## RESPONSE TO FEEDBACK ON IPPC APPLICATION

### Comments made by ERA

## **Attachment 1: Effluent and air emission points**

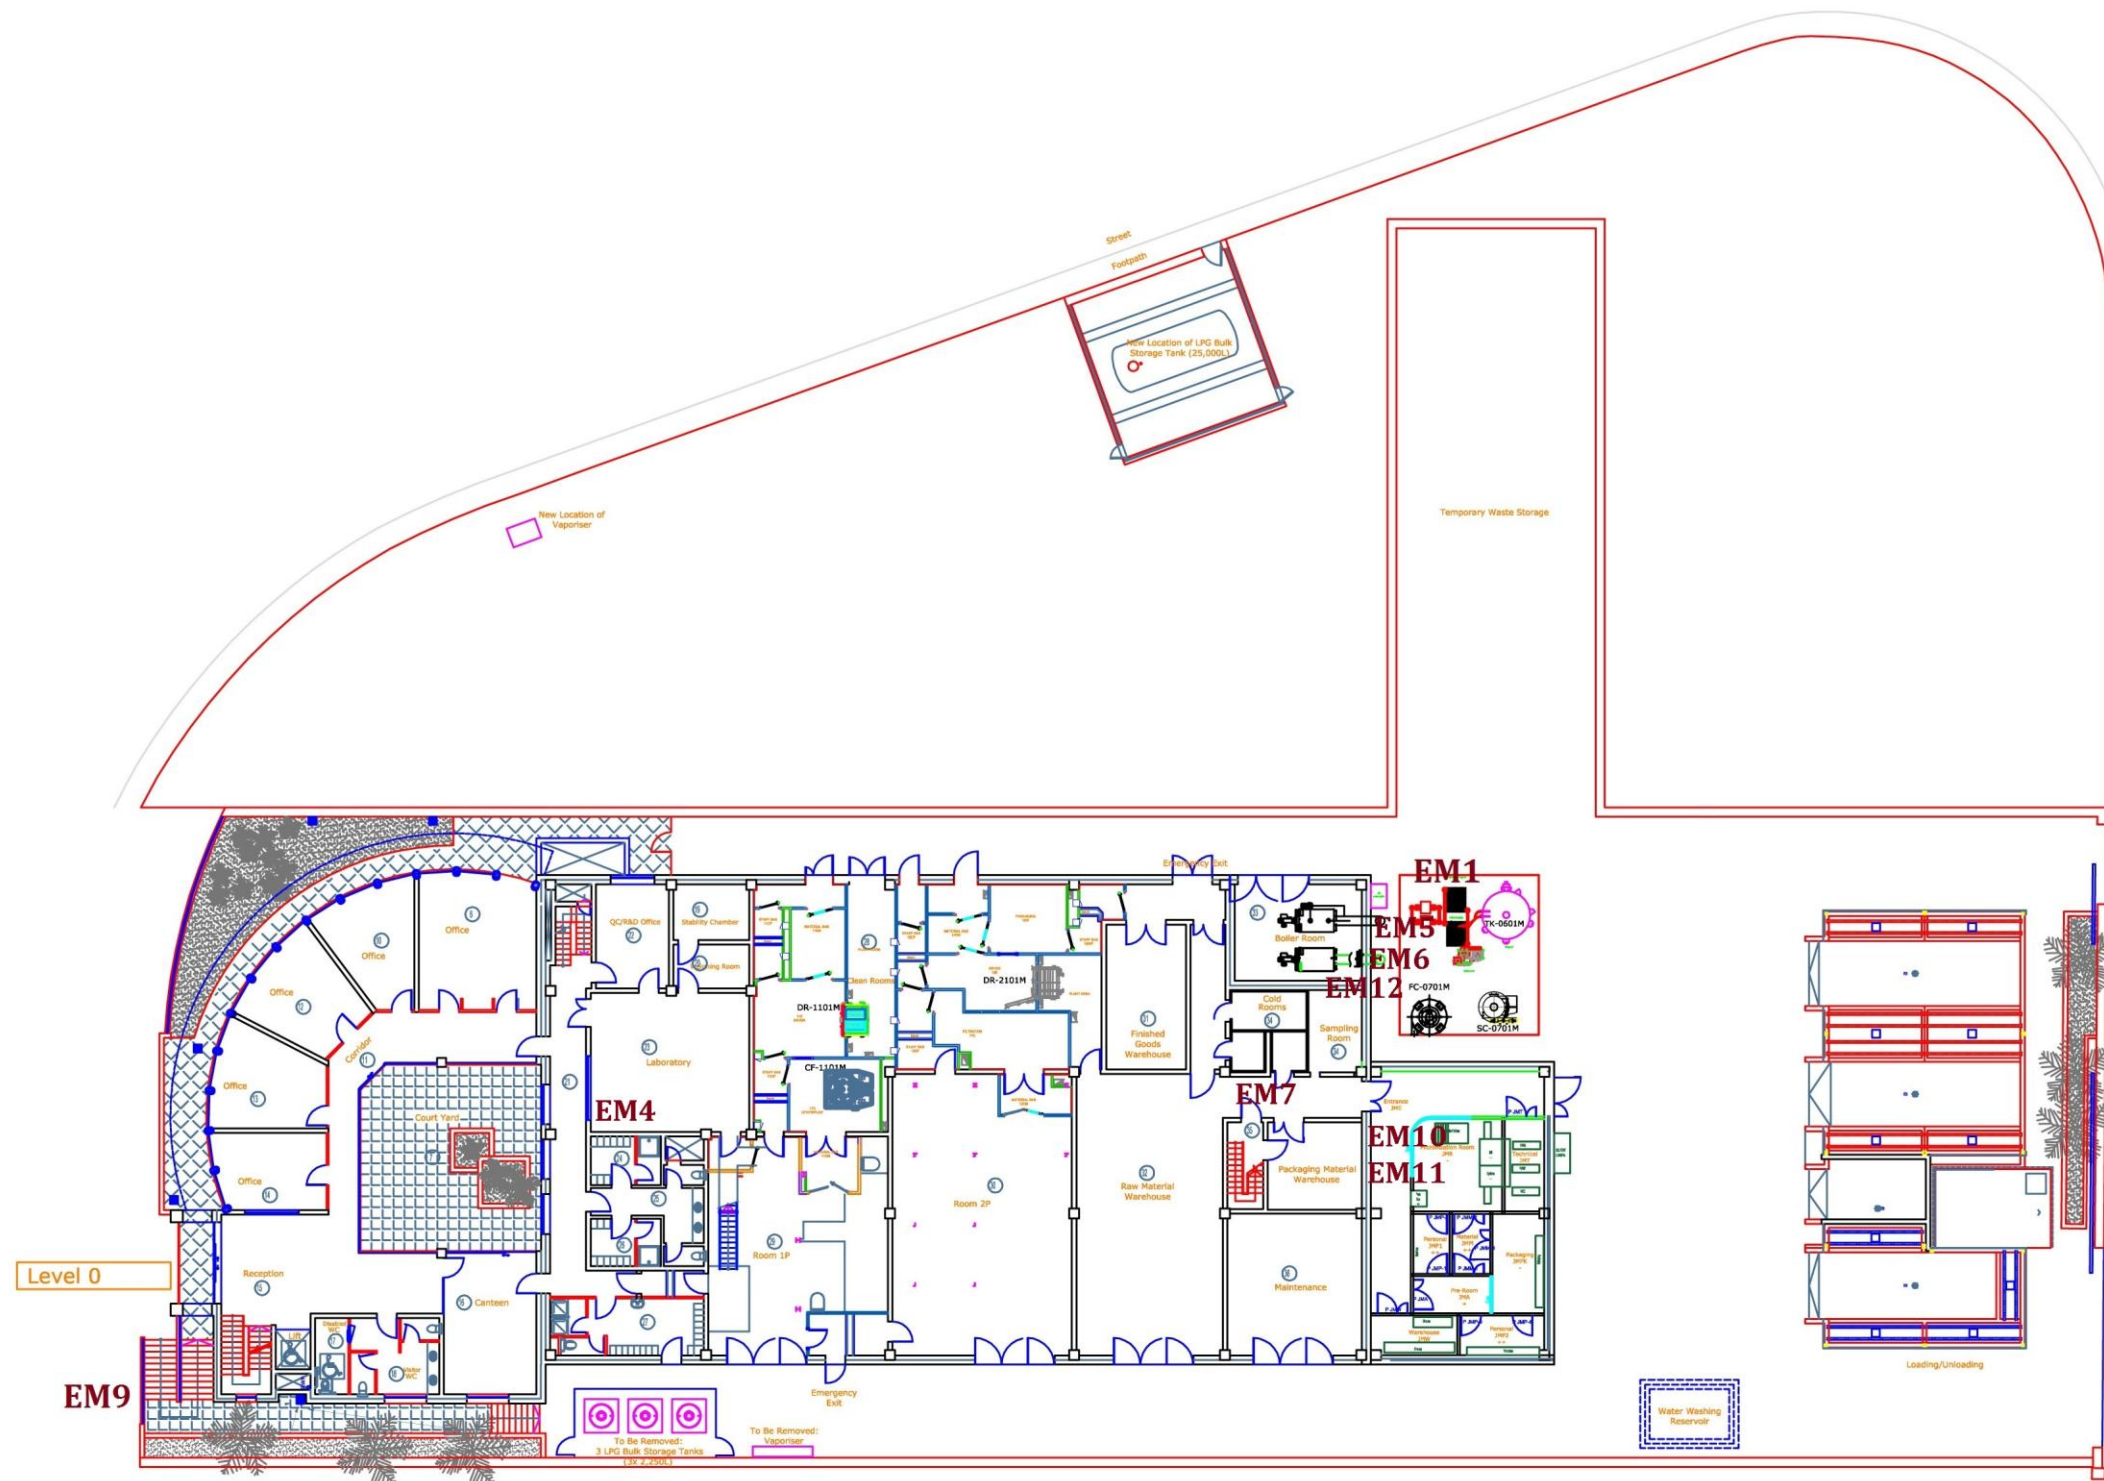
Section	Duly made?	ERA Comments 12 <sup>th</sup> June 2018	Sterling Chemical Malta Ltd replies 28 <sup>th</sup> August 2018	Duly made?	ERA Comments 1 October 2018
C1.1	✓	Noted.	-		
C1.2	✓	<u>Document: VOL 2 - IPPC variation application</u> <u>Chapter 2: C1.2 Non-Technical Description</u> Noted.	-		
C1.3	×	<u>Document: VOL 2 - IPPC variation application</u> <u>Chapter 2: C1.3 The Proposed Variations</u>  In relation to point 2.12 stating that the construction of the micronization facility is covered by DN 0624/16. In an inspection carried out at the facility on 5 April 2018 it was noted that works were still ongoing. In this regard, and in view that the development permit expired on 14 September 2017. Kindly clarify whether the applicant is in possession of a valid development permit.  In relation to the permit conditions which are foreseen in view of this variation, kindly note that the number of emission points to air will need to be updated two include the two new emission points from the fume hoods.  In this regard, kindly note that an update to the Effluent and Air Emission Points (Schedule 3A of IP0001/14) is required.	Sterling Chemical advises that construction works were complete by this date, and only finishing works were underway.  Noted.  Please see <b>Attachment 1</b> .	✓	<u>Document: VOL 2 - IPPC variation application</u>  <u>Chapter 2: C1.3 The Proposed Variations</u>  Noted.  <u>Document Volume 2- IPPC variation application</u>  <u>Figure 4.9: Emissions points from the Scheme pg 65</u>  Updates have been noted.

**Attachment 3: Fire detection and fire fighting plan for micronisation plant**

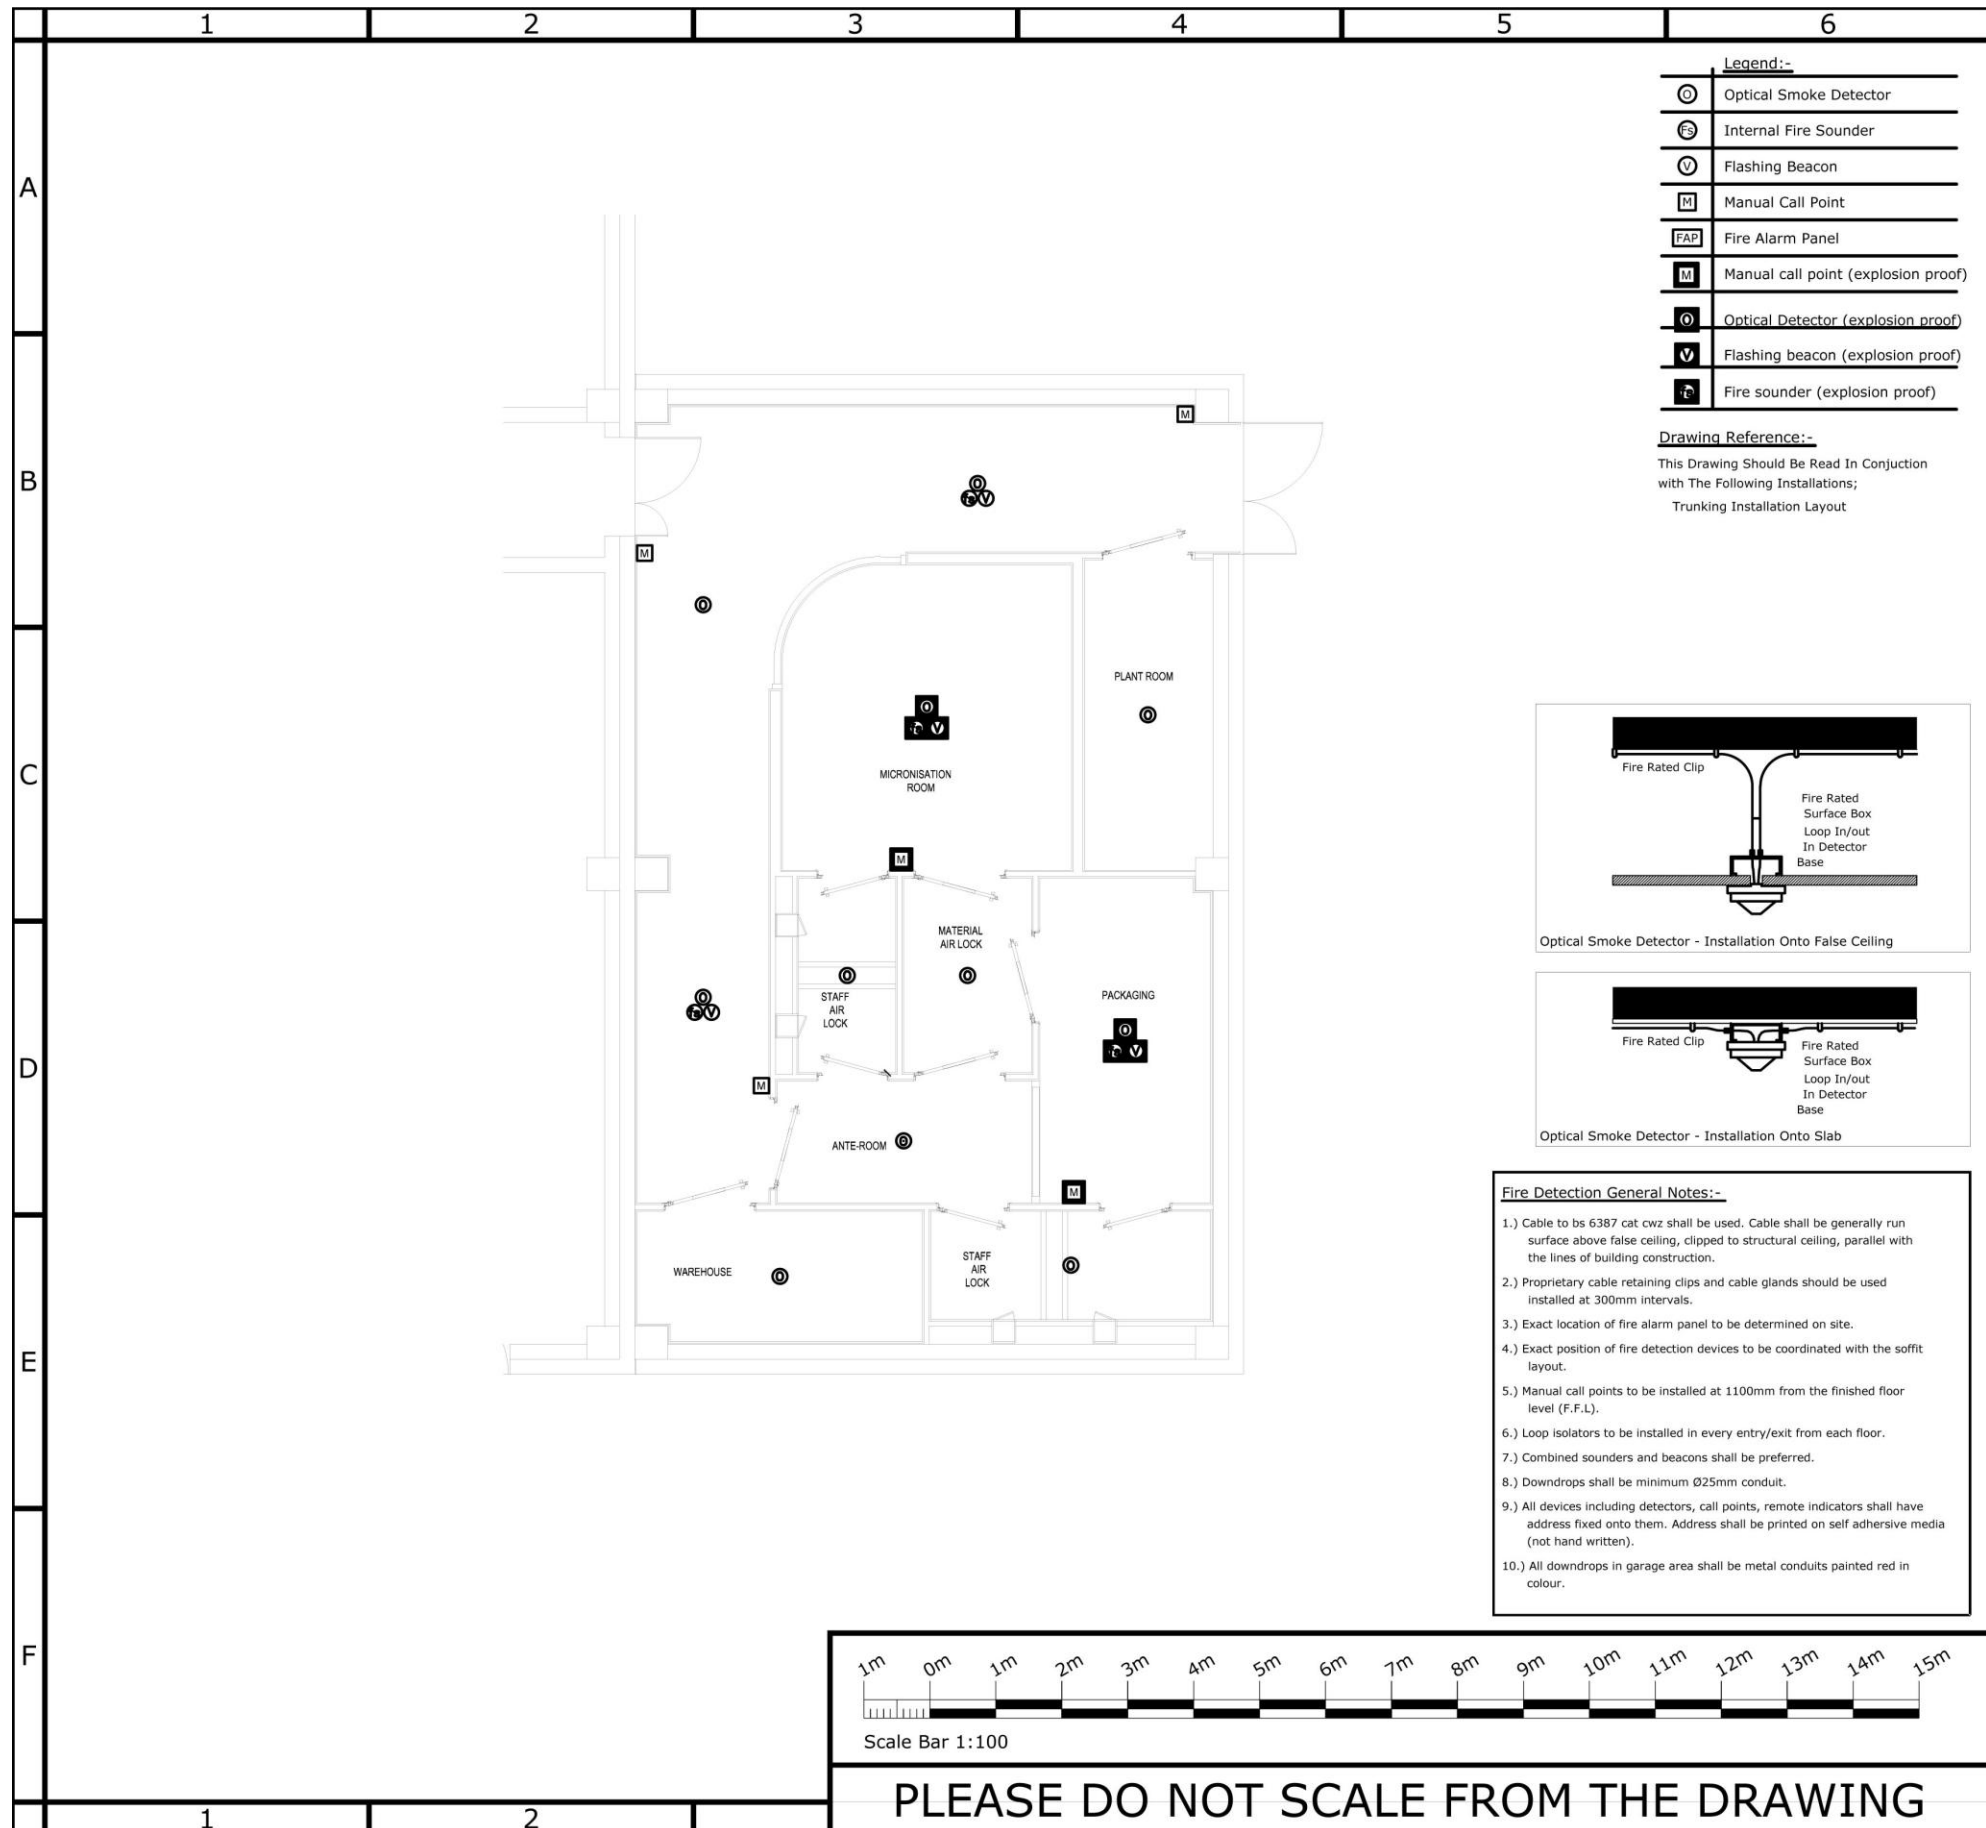
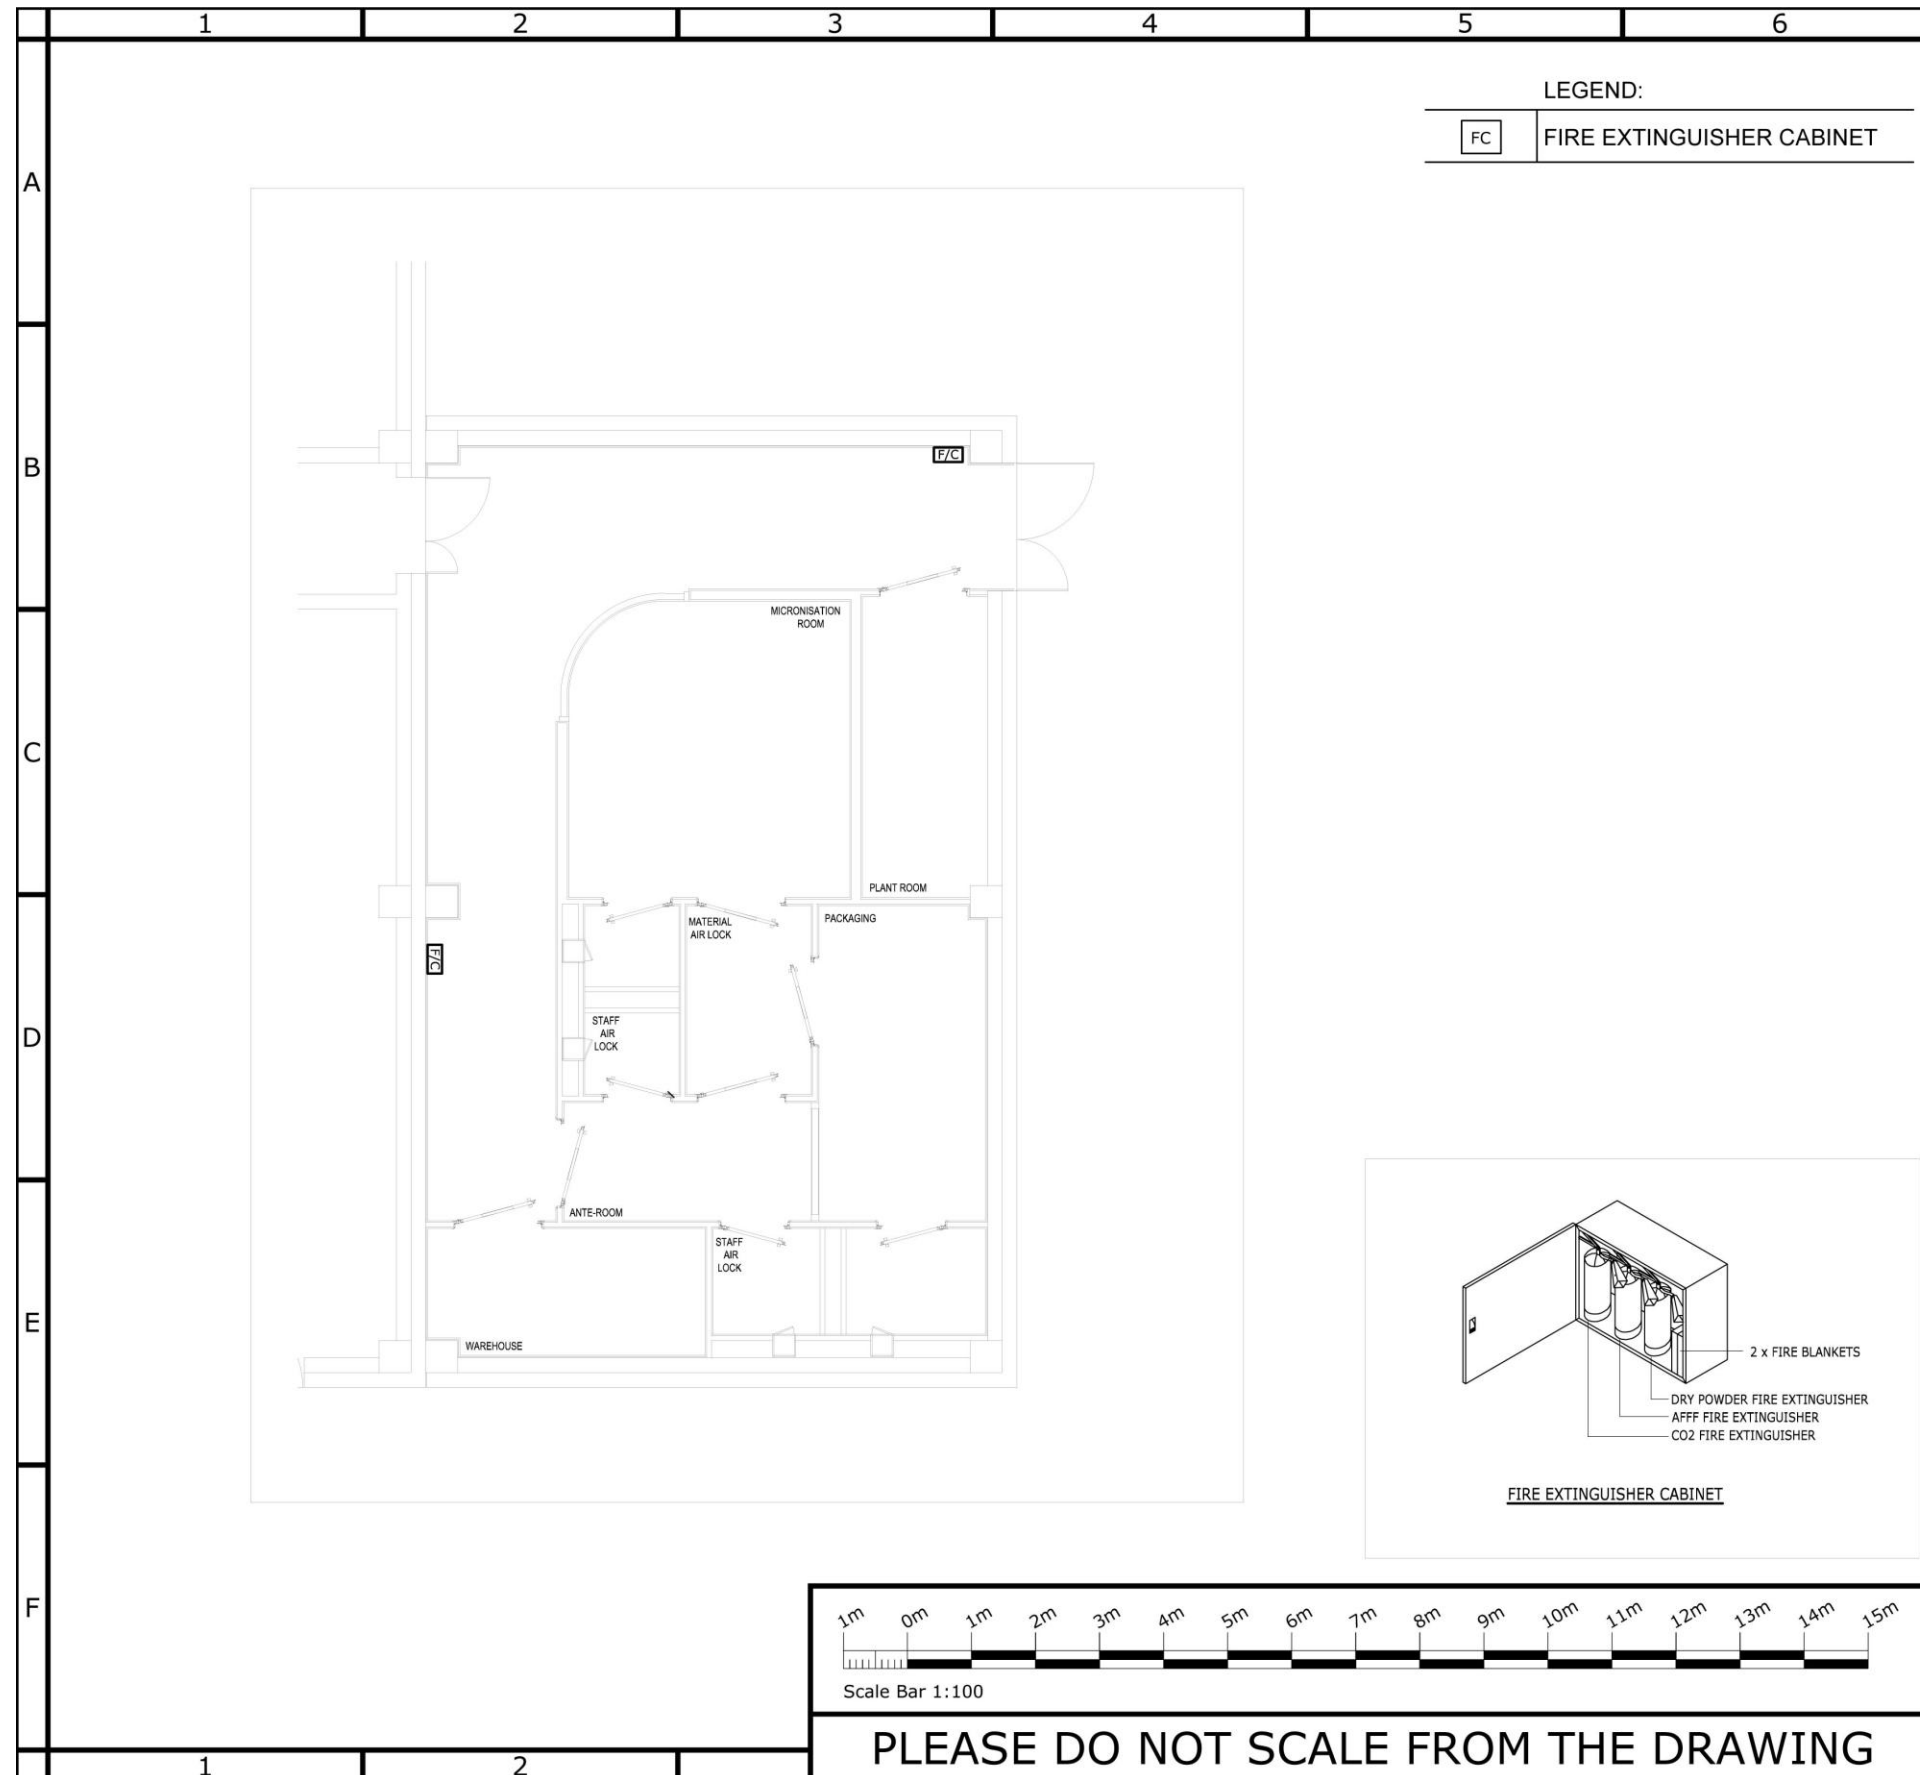
6) Kindly submit the 'fire detection and fire fighting plan' to ERA.	application have been updated.  6. Please see <b>Attachment 3</b> . This covers the micronisation facility; following a review by the fire consultants no such systems were considered necessary for the cold rooms, being cold and damp rooms (nevertheless, a fire extinguisher is already located right outside the corridor leading to the cold rooms). Firefighting measures for the new temporary waste storage area are as described in section C2.8; those for the new LPG tank will be defined by the fire consultants at a later stage.		
C1.4.2	×	Kindly submit amended maps in view of the inclusion of the waste management area.	Please refer to <b>Volume 3</b> .	✓	Noted
C1.4.3	×	<u>Document: Volume 3: Addendum 1 to Land &amp; Groundwater Risk Assessment</u>  Kindly note that block plans are to be updated to reflect also the introduction of the LPG storage tank as well as the recently constructed waste management area.	Please refer to <b>Volume 3</b> .	✓	<u>Document: Volume 3: Addendum 1 to Land &amp; Groundwater Risk Assessment August 2018</u>  Noted
